KC750 TO KW11-K

DECOLOG Engineering Change Order Log

FIELD CHANGE ORDER

FCO KC750 P 0001 PAGE 1 of 13

Figure 1

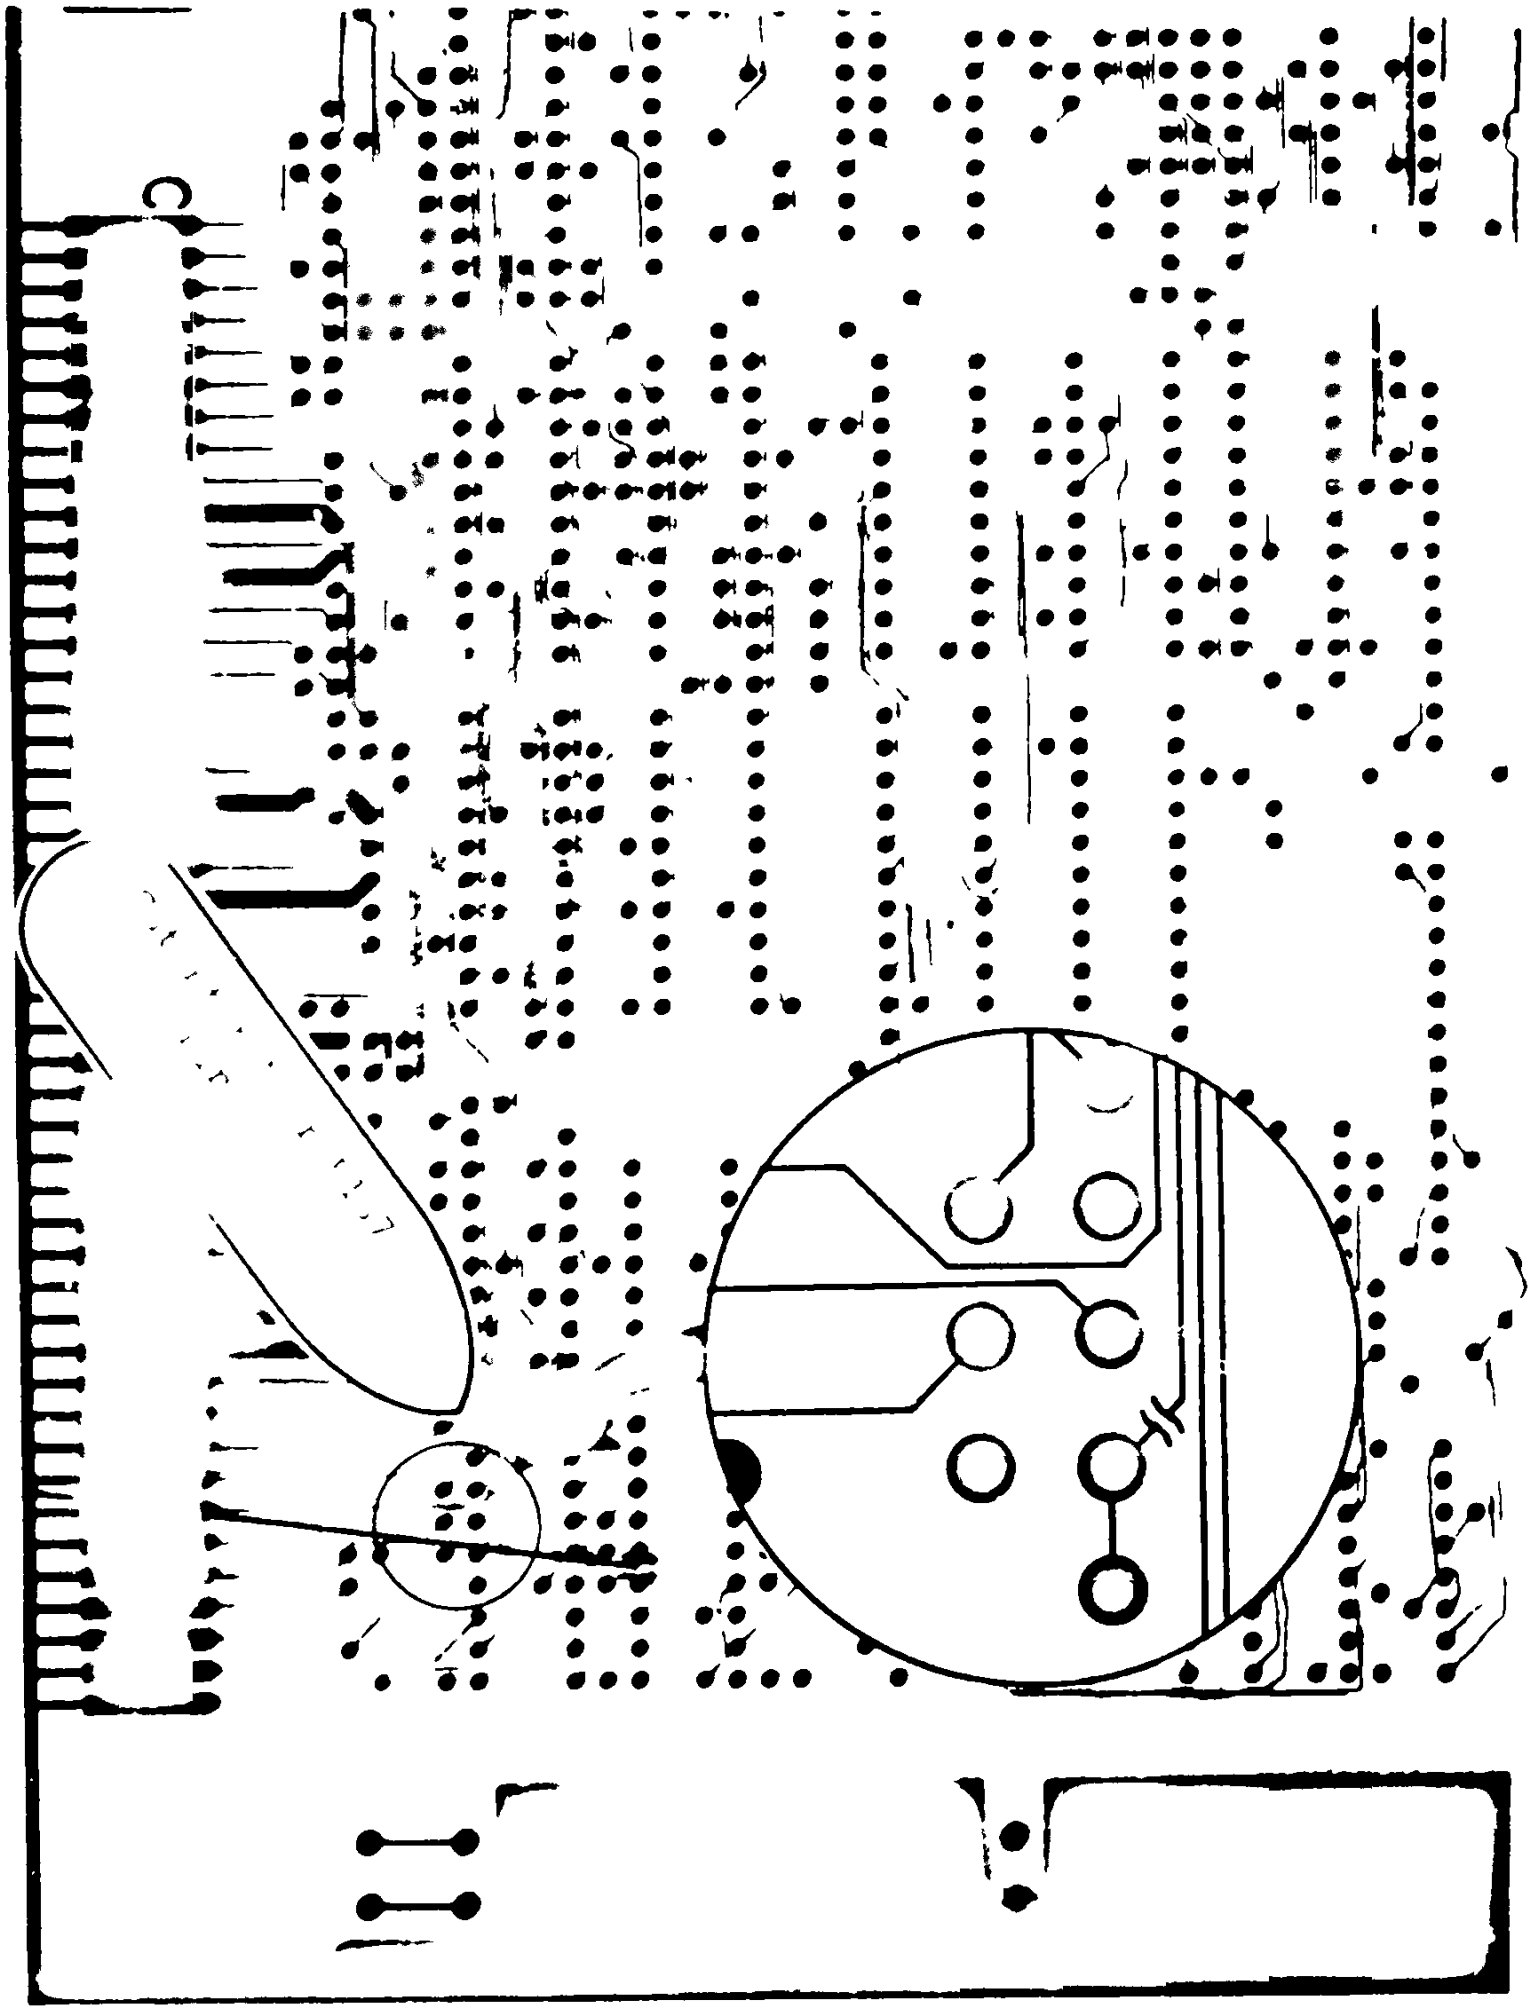
5. Cut etch, side 2, between E176 pin 24 and E187 pin 5 near E187 pin 5 (Figure 1).

Figure 2

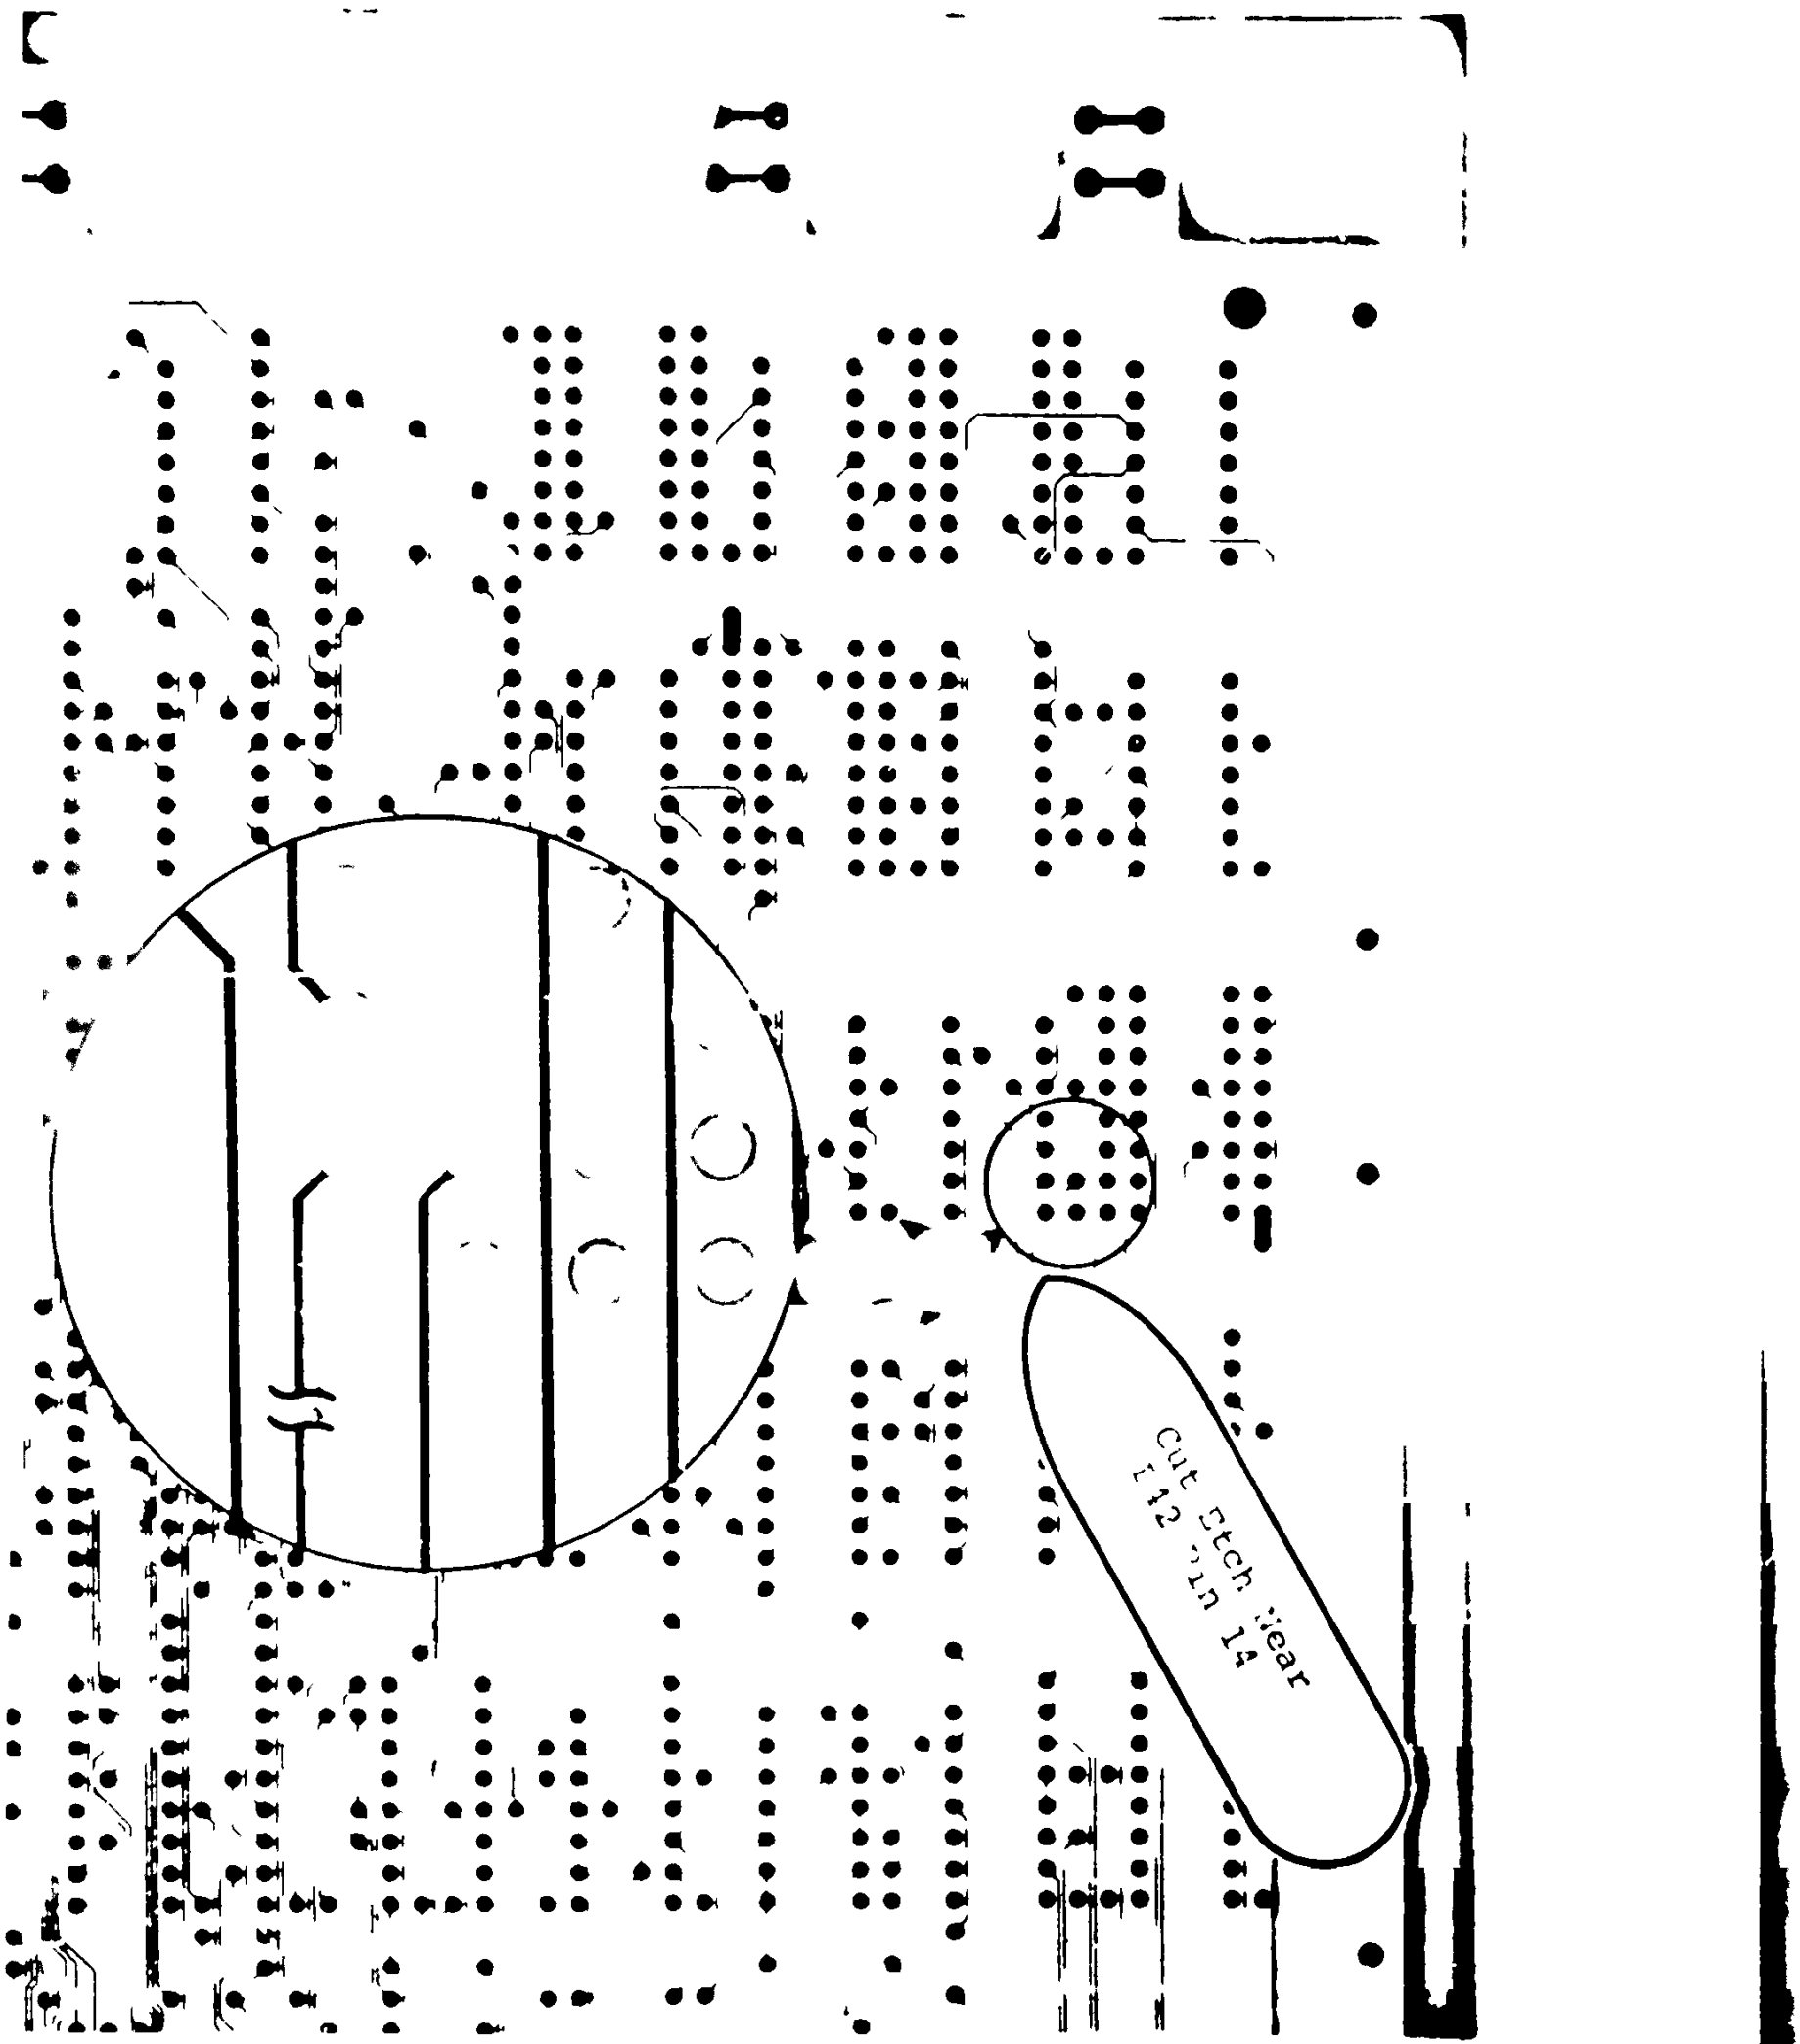
6. Cut etch, side 2, between E42 pin 13 and E56 pin 14 near E42 pin 14 (Figure 2).

Figure 3

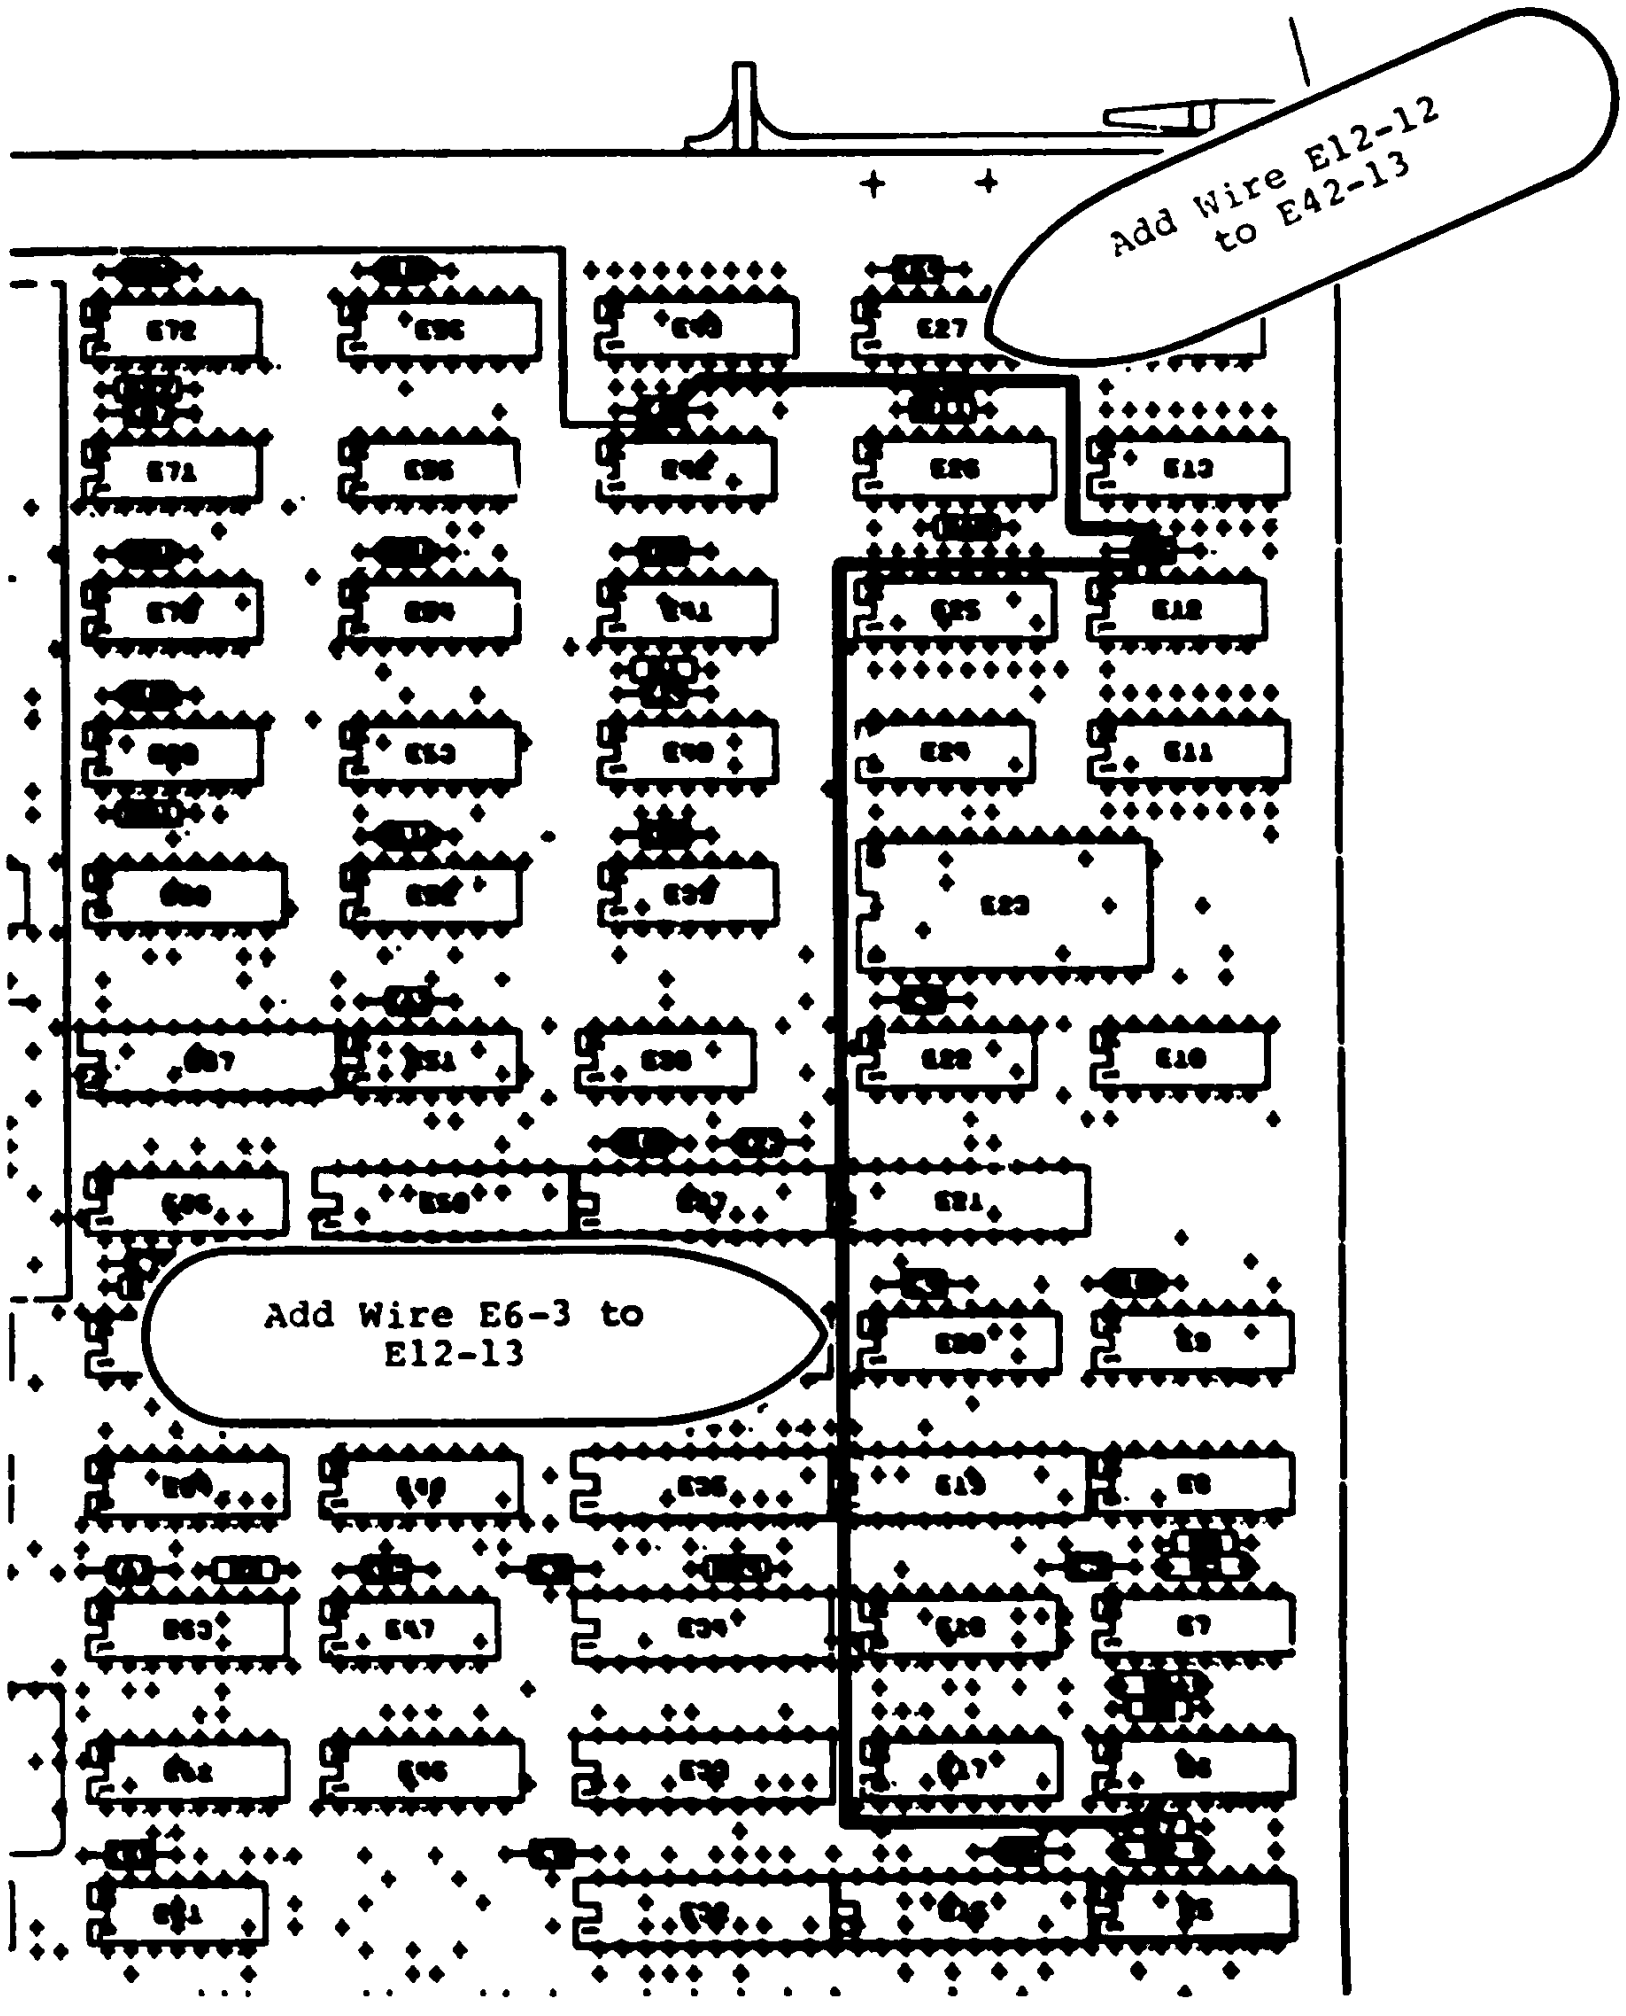
FROM	TO	FIGURE
E12 pin 12	E42 pin 13	figure 3
E6 pin 3	E12 pin 13	figure 3
E6 pin 4	E133 pin 13	figure 4
E133 pin 15	E134 pin 8	figure 5
E133 pin 14	E176 pin 24	figure 6
E133 pin 12	E187 pin 5	figure 6
